Central Sydney Planning Committee

Agenda

Date of Submission:	3 October 2025 Amended plans and information submitted 15 February, 6 March and 1 April 2026
Applicant:	Wentworth Avenue Surry Hills Development Pty Ltd
Architect:	DKO and Aileen Sage
Developer:	Willow Development Group
Owner:	Pongrass Properties Pty Ltd
Planning Consultant:	Planning & Co
Heritage Consultant:	Jean Rice Architect
DAP	4 December 2025
Cost of Works:	\$71,915,857.20
Zoning:	The site is zoned MU1 - Mixed Use under the Sydney Local Environmental Plan (Sydney LEP) 2012. The proposed uses are commercial office and ancillary retail premises, which are permissible with consent in this zone.

Figure 27: Axonometric view of proposal, with DCP envelope and envelope exceedances indicated

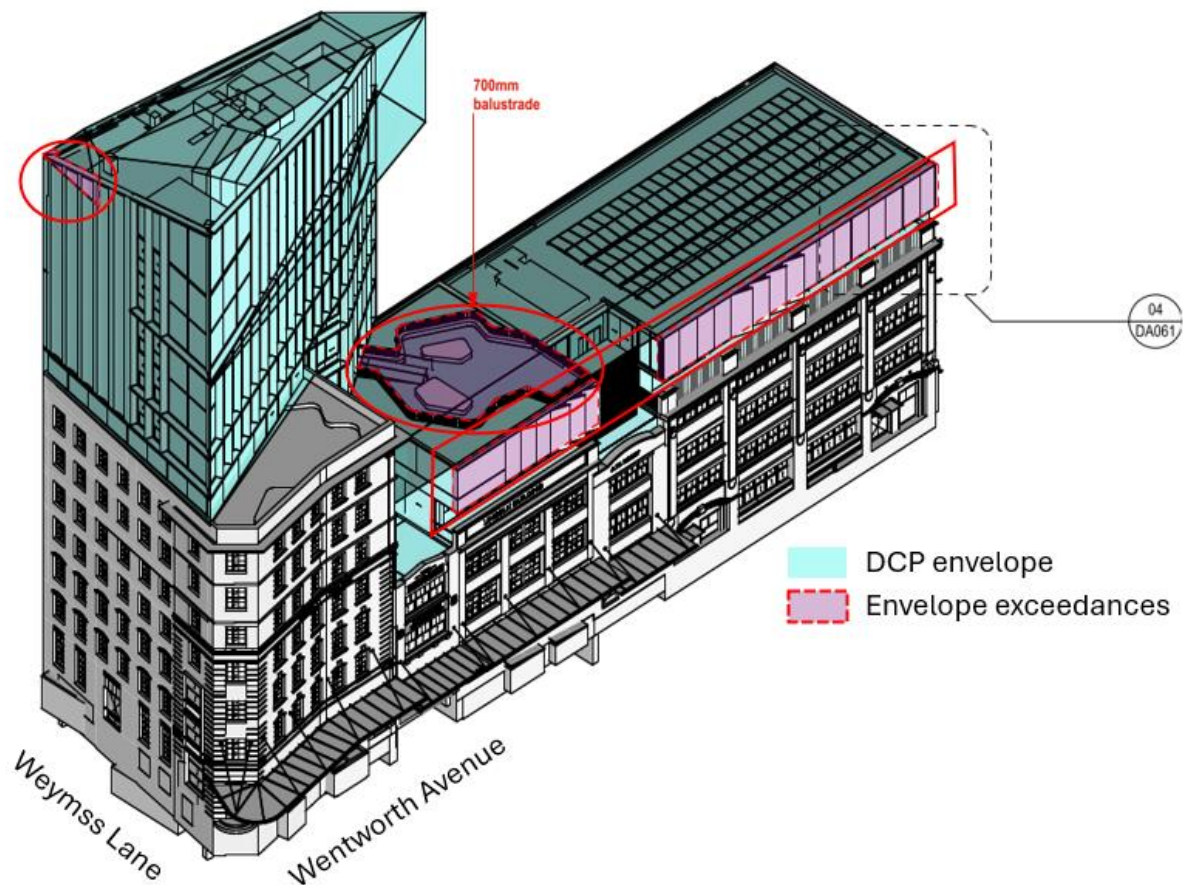
60. The exceedances range from 500mm in depth (the Wentworth Avenue facade) to the 700mm high balustrade above 10-12 Wentworth Avenue. These projections are largely devoid of gross floor area. These projections do not breach the maximum height development standard contained in Clause 6.55 of the Sydney LEP 2012, with the balustrade above 10-12 Wentworth Avenue being excluded from the measurement of building height. The minor exceedances have minimal impact on overshadowing, given their location. See overshadowing discussion below.

Figure 33: Proposed photomontage of the tower addition, depicting the large picture windows and vertical fins (left) and level 10 floor plan of the tower with fins outlined in red to be increased in depth to provide shading

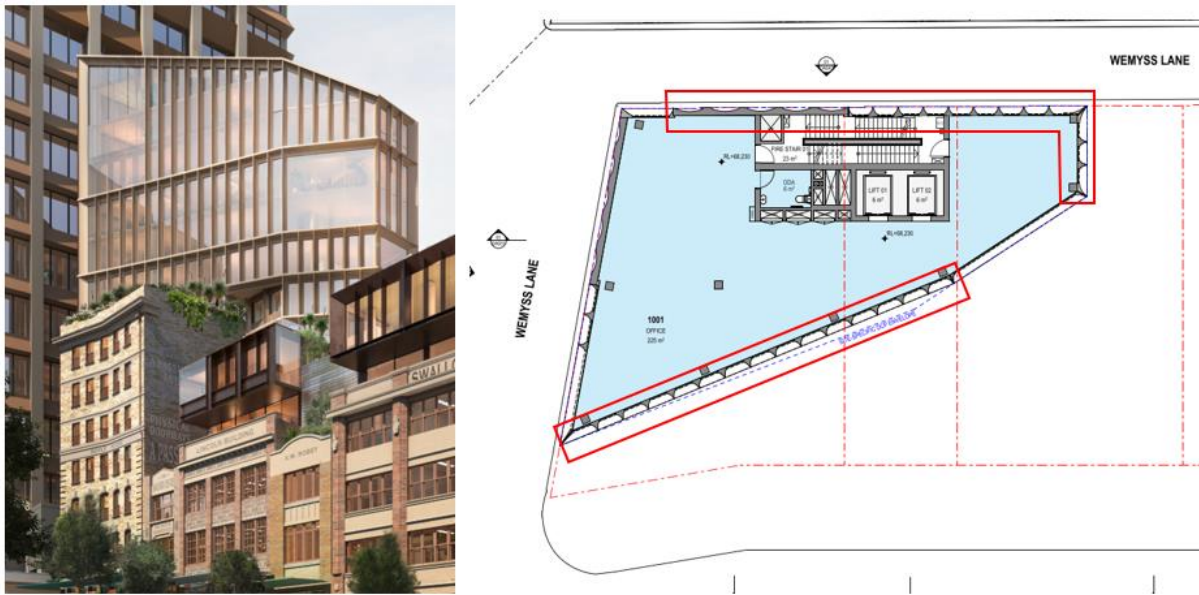
Panel Recommendation	Response
	Noting that the building expression is very similar to that which won the design competition, it is recommended that the vertical fins across the tower facade be extended in depth to 450mm to provide solar shading, with the larger 'picture' to have their own design for external solar shading and glare control which may incorporate triple glazing. The extension of the fins will sit outside of the DCP envelope in some parts, but this is acceptable noting that these are minor architectural elements. See Figure 33 below, outlining fins to be conditioned. An appropriate condition is included in Attachment A.
Generally, the Panel recommends maximising passive energy measures to minimise energy consumption.	The application proposes the installation of solar PV cells above the podium addition and has committed to a 5.5-star NABERS Energy rating.
The Panel supports the proposition and form of the two floating podium elements. However, they appear to be excessively bland and do not have a strong relationship with the heritage buildings below. Further refinement is recommended for light and playful podium elements that respond to the rhythm of the buildings below.	The podium addition has been amended so that the vertical rhythm of the host buildings is expressed as vertical fins, aligning with the different proportions of 10-12 and 16-22 Wentworth Avenue. This, along with the bronze powder-coated framing of the additions provide more consistency across the two podium elements. Within this framework the 'playfulness' is expressed with different fenestration and the northern-most module (above 10-12) being expressed as a glass box. It is recommended that the bays above 10-12 Wentworth Avenue be redesigned to align more appropriately with the DAP's advice. See image and further discussion below.

Figure 34: Amended Development Application submission, depicting the podium additions. The addition above 10-12 Wentworth Avenue outlined in red is recommended for redesign.

Figure 35: Proposed section through 14 Wentworth Avenue, with floors that do not meet the existing facade circled in red

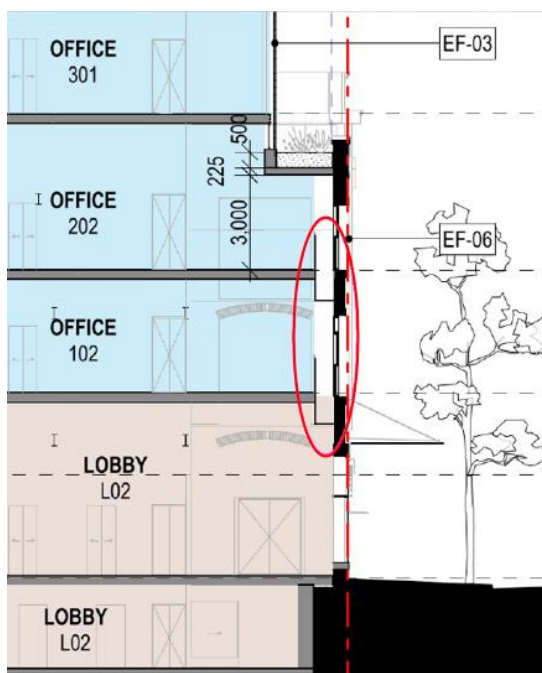
92. Number 14 Wentworth Avenue is to contain new floors that do not meet the existing facade, however there is no information provided on the fire engineering solution. See the affected junctions below, circled in red:

93. The fire engineering solution will need to be determined prior to construction being carried out, to ensure that the impact to the ground level heritage fabric and shopfronts is minimised. A condition is recommended for any works to comply with the National Construction Code, whilst also minimising damage to existing fabric and heritage features. If any upgrading works to address the fire engineering solution are required, details are to be submitted to Council for approval prior to the issue of any Construction Certificate. An appropriate condition is recommended in Attachment A.

Figure 36: Proposed section through warehouse podium addition. Louvres are indicated by red dashed lines.

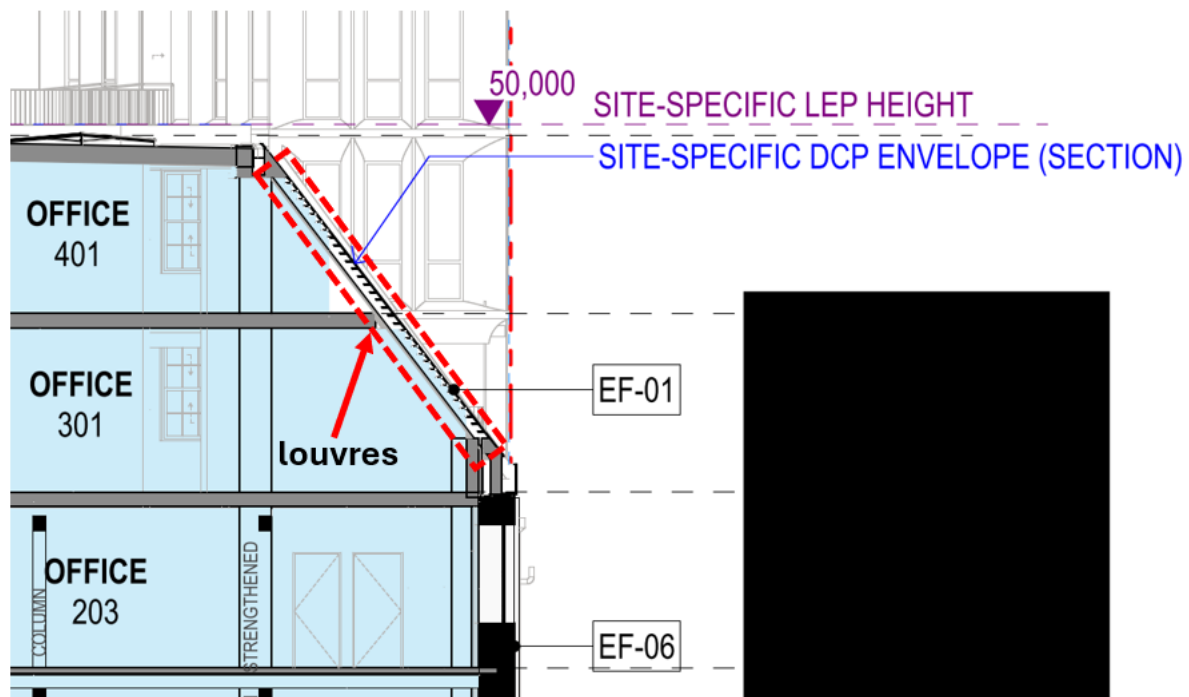
- (b) Levels 3 and 4 are contained within an angled roof to the Weymss Lane elevation. The roof has a nil setback at the floor level 3, however this increases up to 9.4m at the top. The sloping of the roof limits the usability of the area behind. It is noted that in section and elevation, the roof has been designed with louvres to limit privacy impacts to the apartment building, but this has been left off the material schedule. A condition is recommended to ensure the louvres are installed and angled so that direct sightlines to the apartment building are limited. See Figure 36 below.

Figure 37: Proposed level 5 plan. Separation distances between Meta Apartments and the tower are indicated.

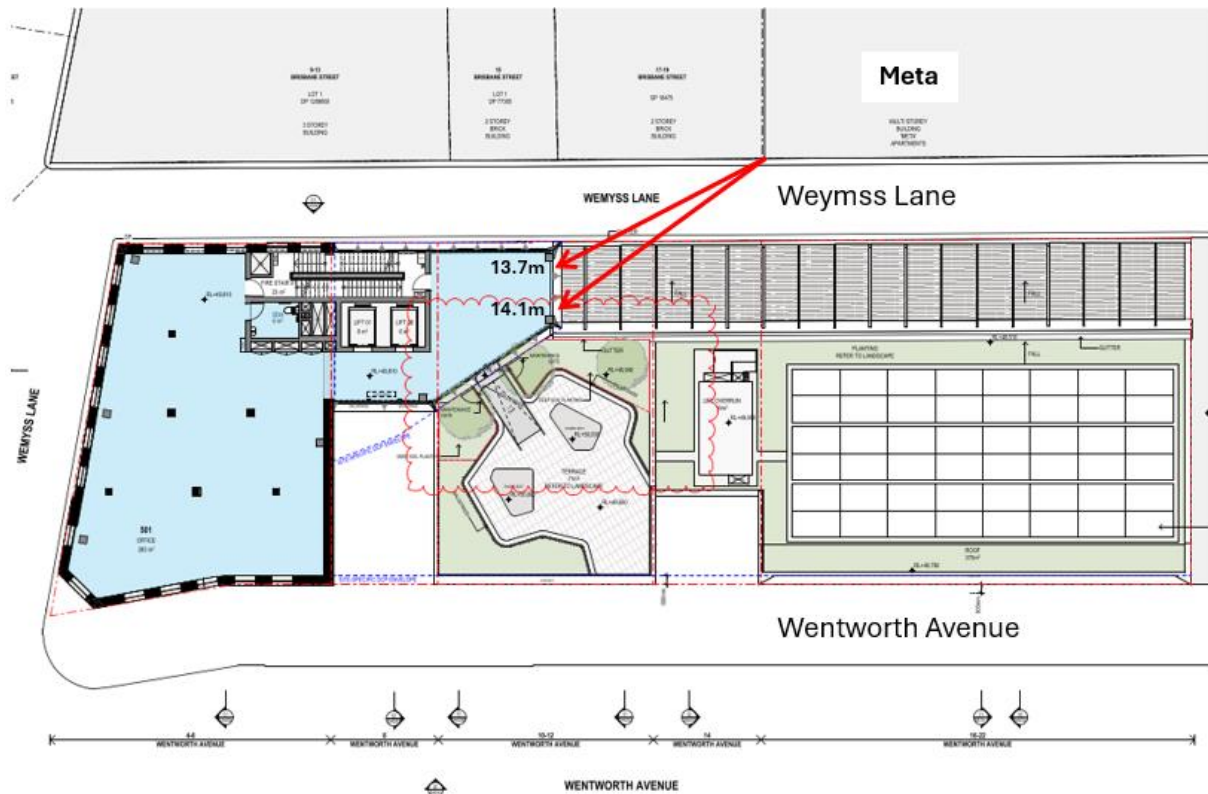
- (d) The tower has been designed so that the faceted corner (south elevation) contains vertical fins at levels 5-7, limiting views out towards 21 Brisbane Street, which is approximately 13.7m away. Levels 8 and above sit higher than the residential apartment building, with little to no direct views. The separation distances in this location comply with the ADG. See level 5 plan below (levels 6-7 and similar for tower separation).

99. On balance, the proposed proximity of commercial development to the existing residential apartments is acceptable, subject to conditions.
